Addendum 7

Sugarcreek Water Treatment Plant and Wellfield Improvements

Addendum No. 7
June 6, 2022

SCALE: 1/2" = 1'-0"

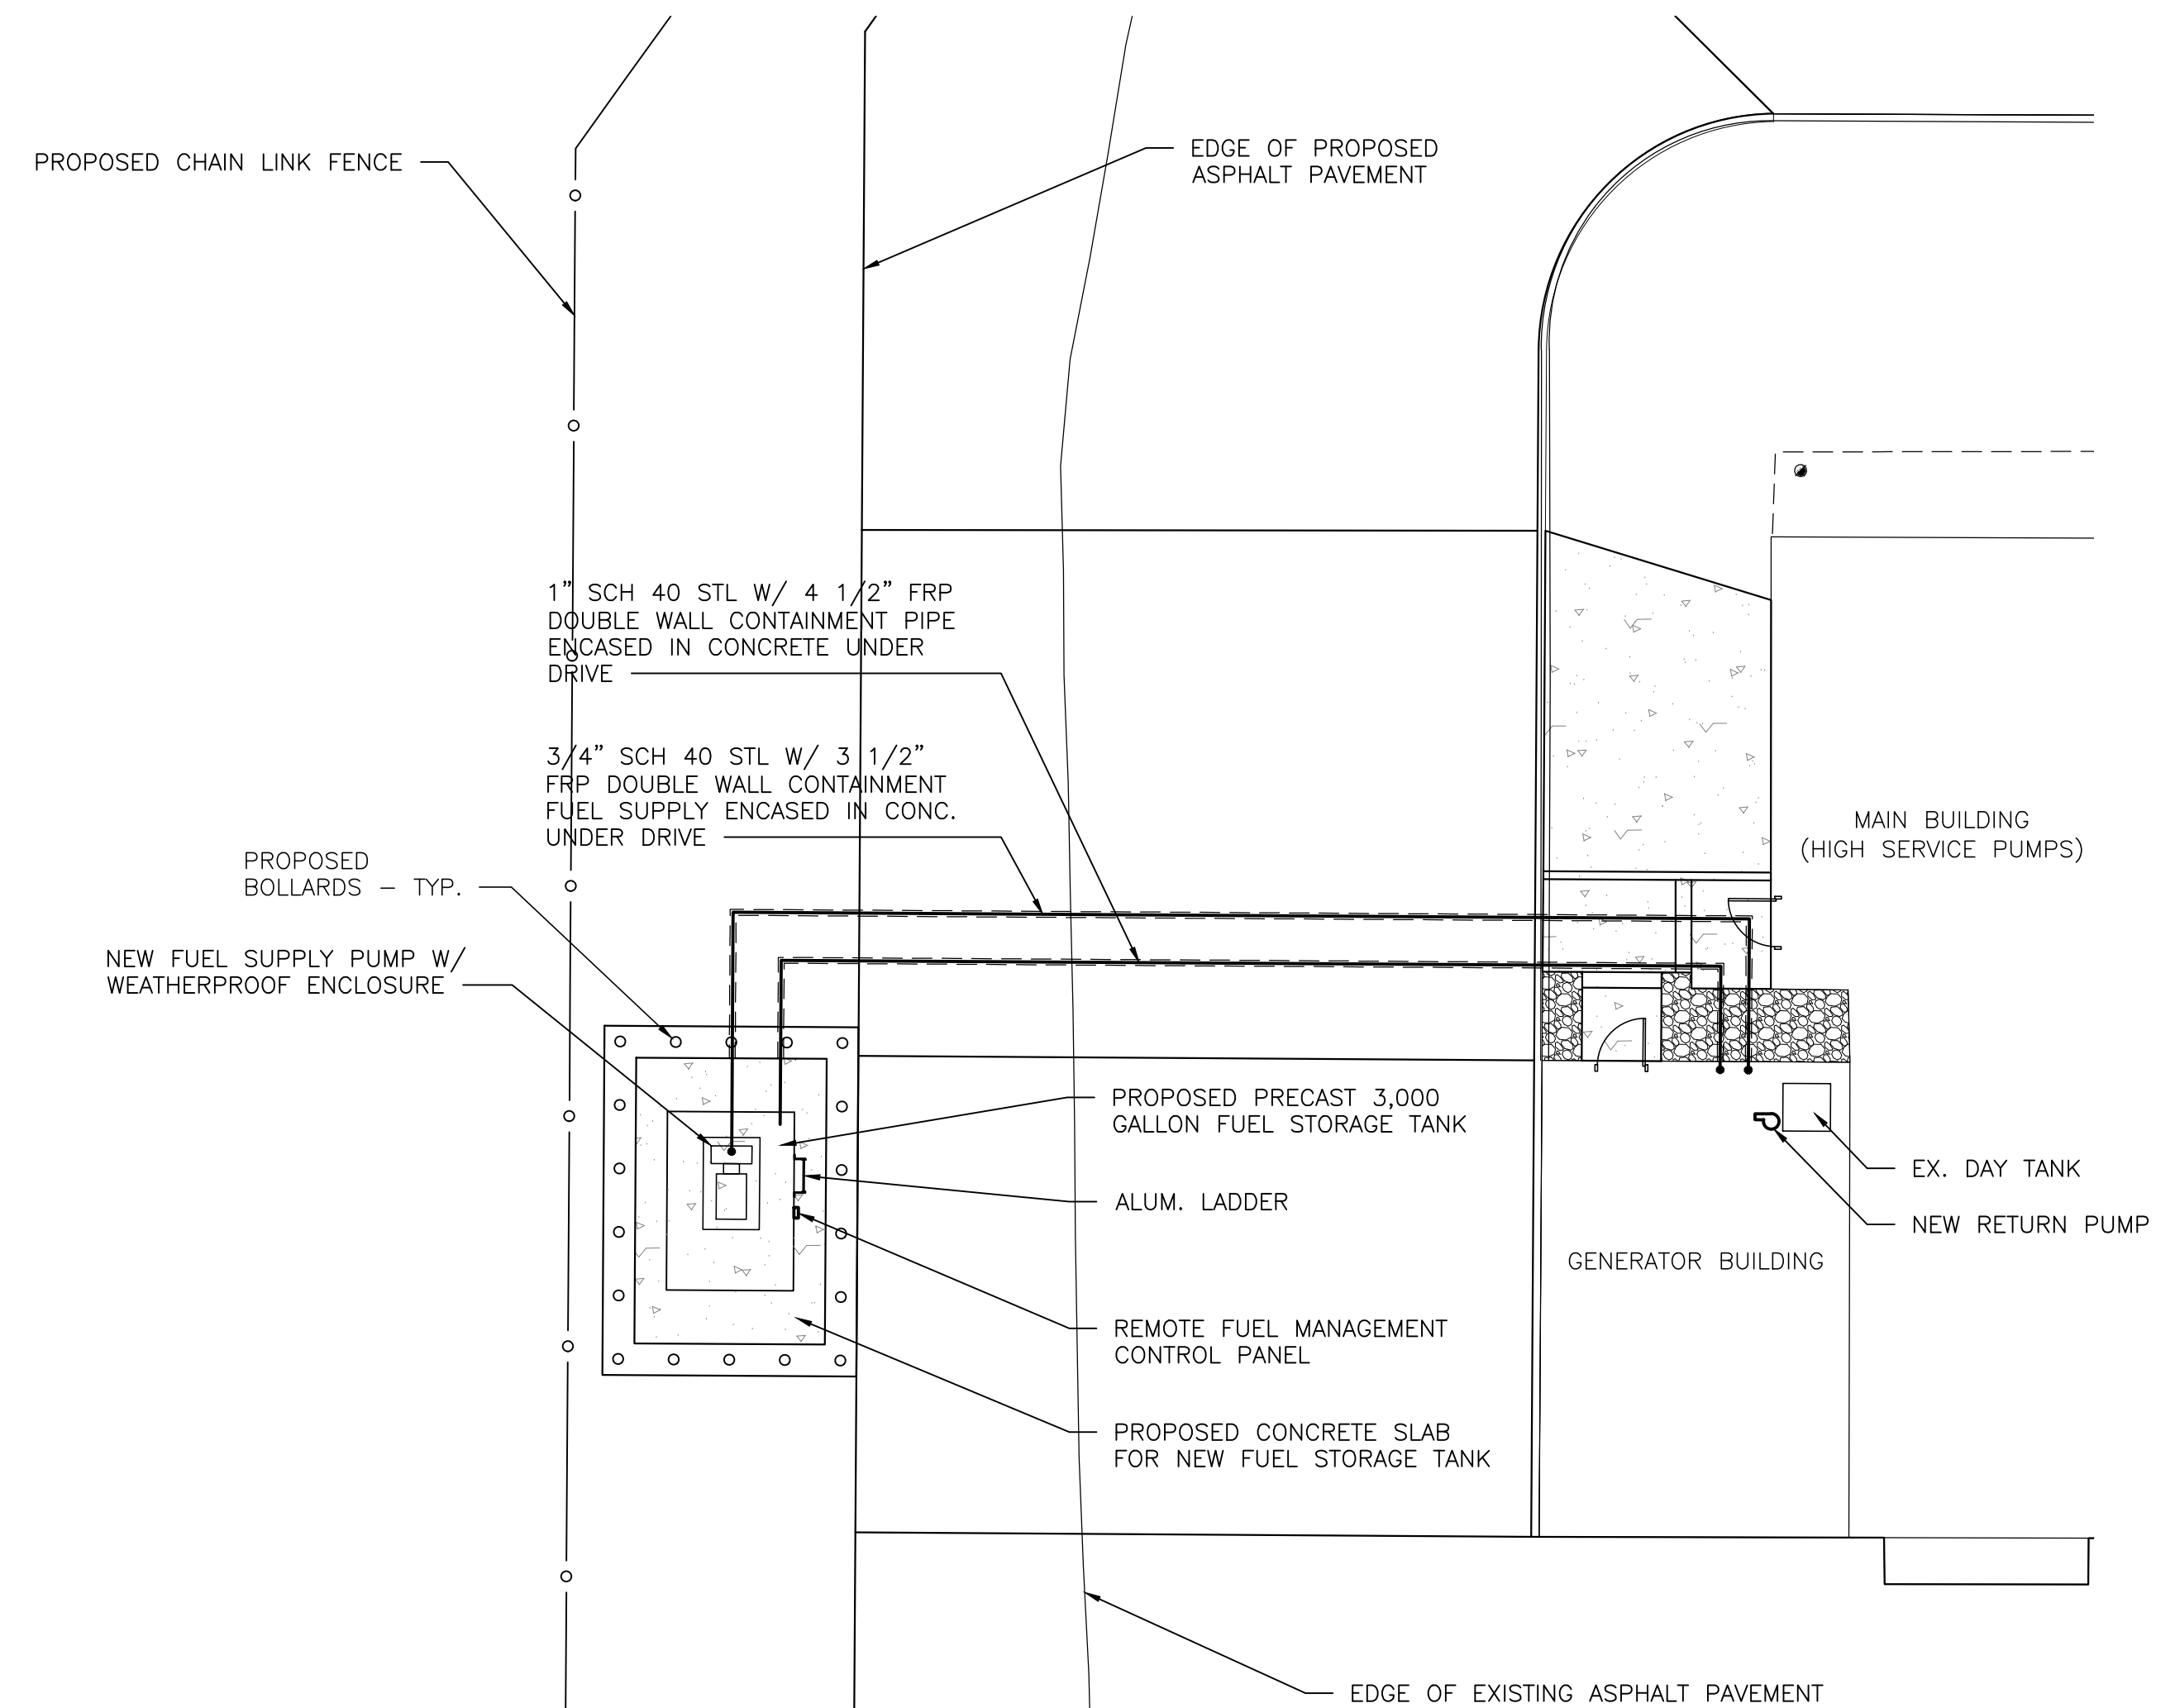
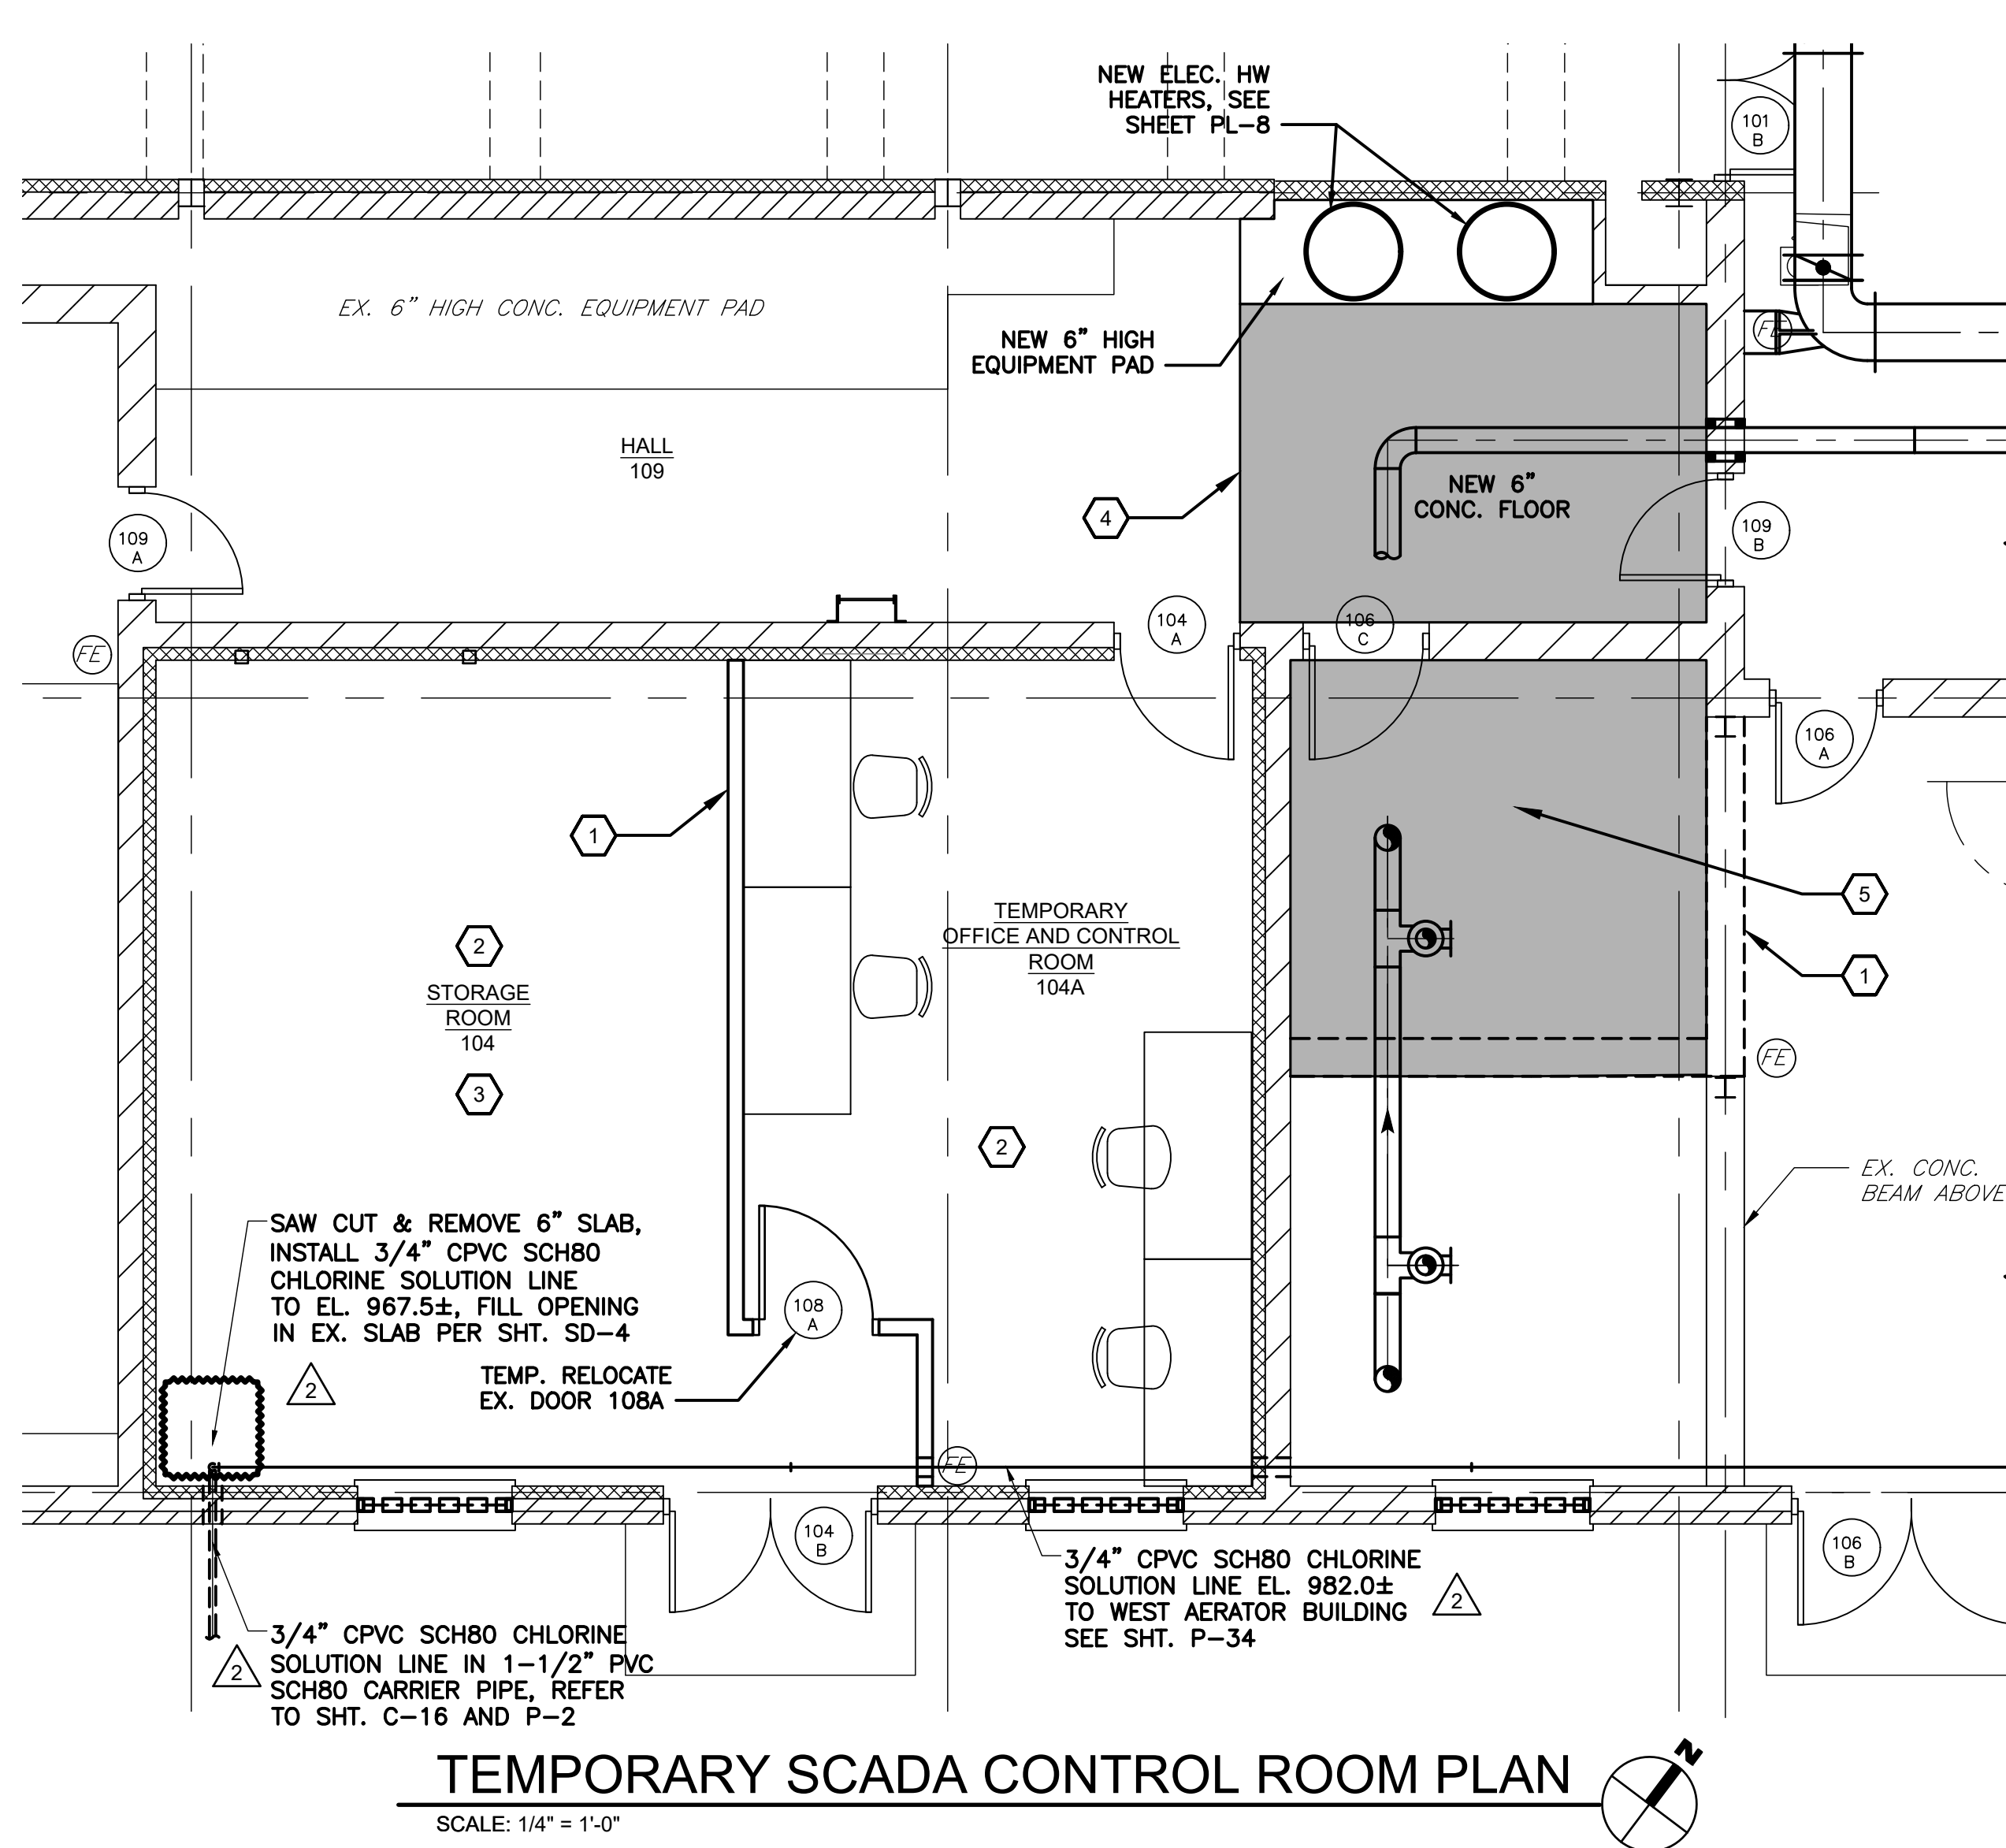
6. **Sheet C-11, Fuel Storage Tank Civil Enlarged Plan – Section.** REPLACE with the attached C-11. A piping schematic for the Aboveground Fuel Tank is included in the revised sheet to show the fuel supply and return lines to be provided in a concrete encased double containment system. A ladder and a weatherproof enclosure for a fuel supply pump were added.
